**Presentation from
Anna Tilman**

**BWXT Nuclear Energy Canada Inc.,
Toronto and Peterborough Facilities**

Application for the renewal of the licence for
Toronto and Peterborough facilities

Commission Public Hearing

Beryllium Concentration in Water ($\mu\text{g/L}$) 2011 - 2019

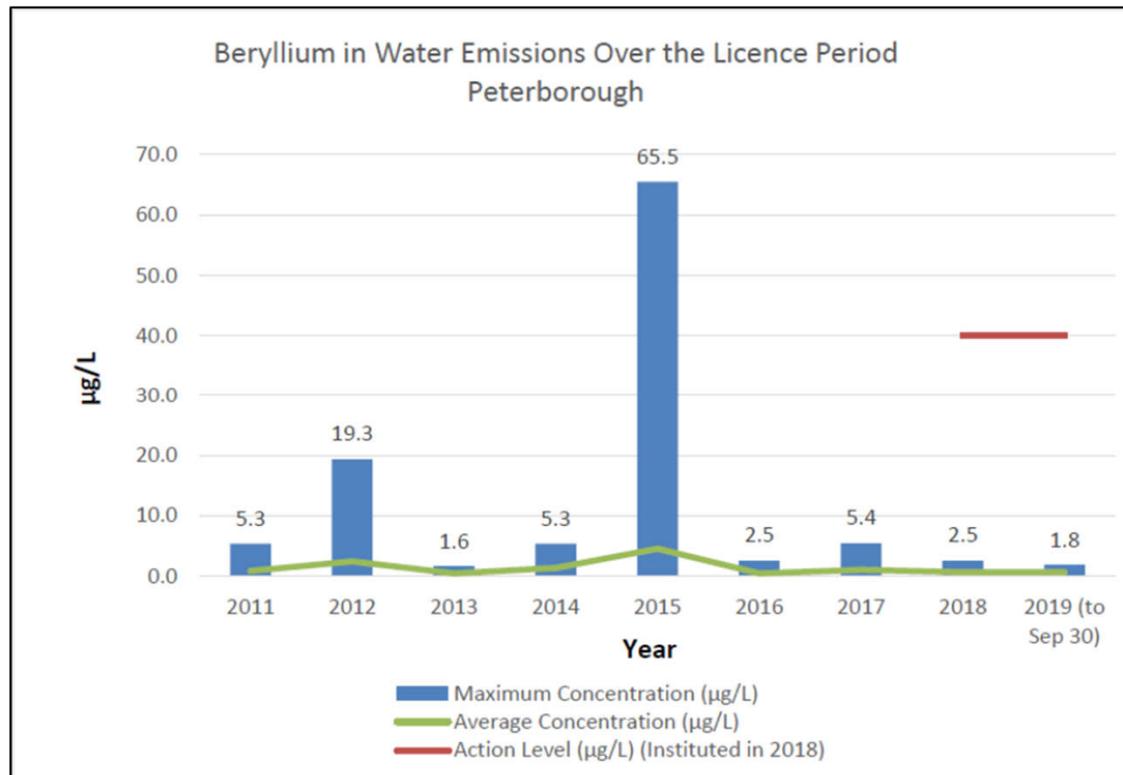
The Action Level is $40\mu\text{g/L}$. For the year 2015, the maximum concentration is $65.6\mu\text{g/L}$, the average concentration is approximately $4\mu\text{g/L}$.

Impact of averaging emissions - Averages mask the necessary detail that would demonstrate anomalies.
